It has come to my attention that the management of the Davis-Besse Nuclear Power Station at Oak Harbor, Ohio has purchased an unused RPV head to replace the existing damaged head. Given the record of stress corrosion degradation of alloy 600, the subsequent cracking of the nozzles made of this alloy and the uncertainties involved in the ability to discover major damage before a calamity occurs, it would be irresponsible to simply make this replacement without further modification.

The main reason I am writing to you is to point out what I believe to be a major design flaw in the RPV head assembly and to suggest a possible remedy.

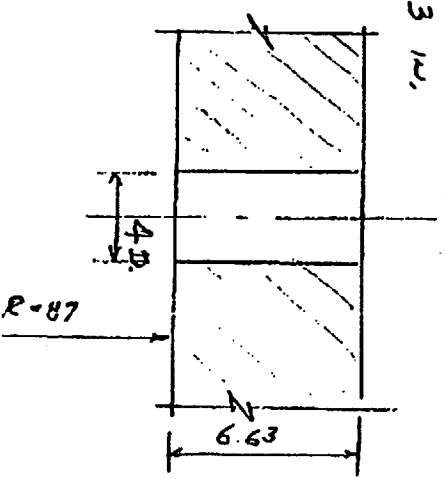
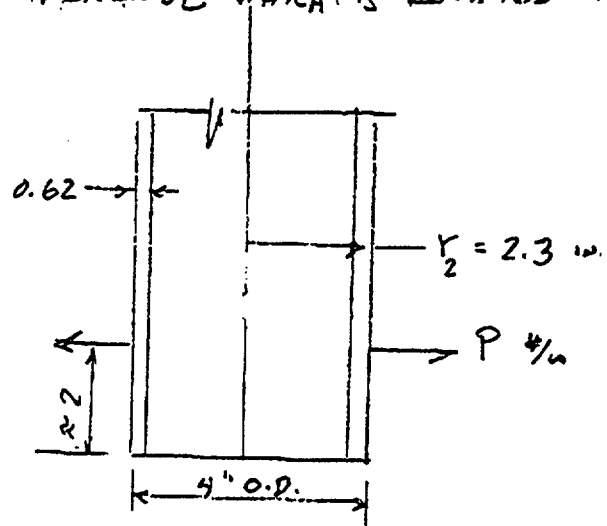
In the present configuration the alloy 600 nozzle is welded directly to the RPV head. The radial deformation at the penetration due to the biaxial membrane stress in the head is transferred to the alloy 600 nozzle through the J weld resulting in a hoop stress of about 26000 psi and meridional bending stress of about 47000 psi. Given the susceptibility of alloy 600 to stress corrosion cracking these stress levels are much too high. Calculations leading to these stresses is shown on attachments A1 and A2.

THE TANGENTIAL STRESS AT THE EDGE OF THE 4" D. PENETRATION IS TWICE THAT OF THE PRIMARY MEMBRANE STRESS OR 29500 PSI

THE ALLOY 600 NOZZLE AT THE J WELD WILL BE FORCED TO SUFFER ABOUT THE SAME RADIAL DISPLACEMENTS AS A RESULT WE CAN IDEALIZE THE ALLOY 600 NOZZLE AS A CYLINDER SUBJECTED TO A RADIAL FORCE OF $P \text{ #/in.}$ OF CIRCUMFERENCE WHICH IS RELATED TO Δr BY

THE MAXIMUM HOOP STRESS IN THE ALLOY 600 NOZZLE IS

$$\sigma_2 = \frac{P r_2 \lambda}{2 t} = \frac{12800 \times 2.3 \times 1.08}{2 \times 0.62} = \underline{\underline{25640 \text{ #/in}^2}}$$

THE MAXIMUM MERIDIONAL BENDING STRESS IS

$$\therefore \sigma_M = 6 \times 2960 / 20 = 46700 \text{ #/in}^2$$

What I propose, as shown in attachment A3, is that a ferritic steel nozzle extension be welded directly to the RPV head and the seal weld to the alloy 600 nozzle be located at the end of the ferritic nozzle about 4 inches away

from the head. The membrane and bending stresses in the ferritic steel nozzle at its juncture with the head would be about the same as those existing now in the alloy 600 nozzle. However, by welding the alloy 600 nozzle to the ferritic steel nozzle away from the RPV head, these stresses would attenuate to about 1000 and 7000 psi respectively. The added ferritic steel nozzle could absorb the high stress levels since they are secondary stresses and there is little concern for stress corrosion cracking here. On the other hand, the decreased stress levels in the alloy 600 nozzle would increase the reliability against cracking, leaking and corrosion of the RPV head enormously.
